From: Orenak, Michael
Sent: Wednesday, September 7, 2022 5:38 PM
To: michael.tschiltz@gmail.com; Chisholm, Brandon Michael
Cc: Sebrosky, Joseph
Subject: NRC Comments on TIRICE draft guidance document.
Attachments: TIRICE Guidance DRAFT Rev D_final_NRC Comments_CLEAN.docx

Technology Inclusive Risk Informed Change Evaluation (TIRICE)
For Non-Light Water Reactors

Draft Report Revision D
Issued for Collaborative Review

Document Number
SC-16166-108 Rev D

Figure 2. Overall Plant Performance Change in Example 1

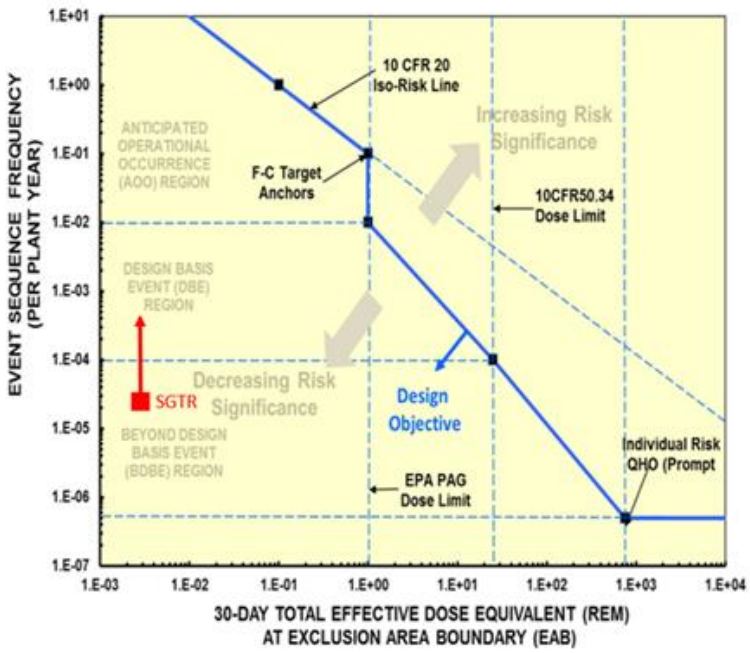
However, the figure seems to depict a change in event sequence frequency from BDBE to DBE. If this were the case, then a new DBA would be introduced based on this new DBE.

Please clarify.

Figure 3. Overall Plant Performance Change in Example 2

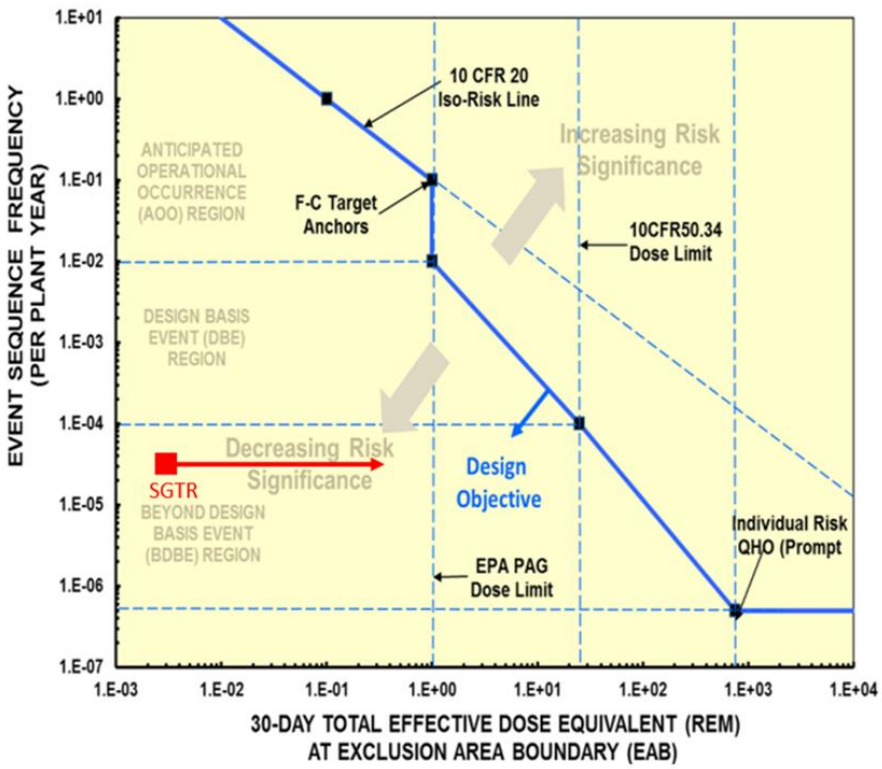
Commented [A60]: If this example event sequence was a DBA rather than the BDBE depicted, then this change would likely screen in based on the "more than minimal increase in consequences" scope of Criterion (c) below, correct?
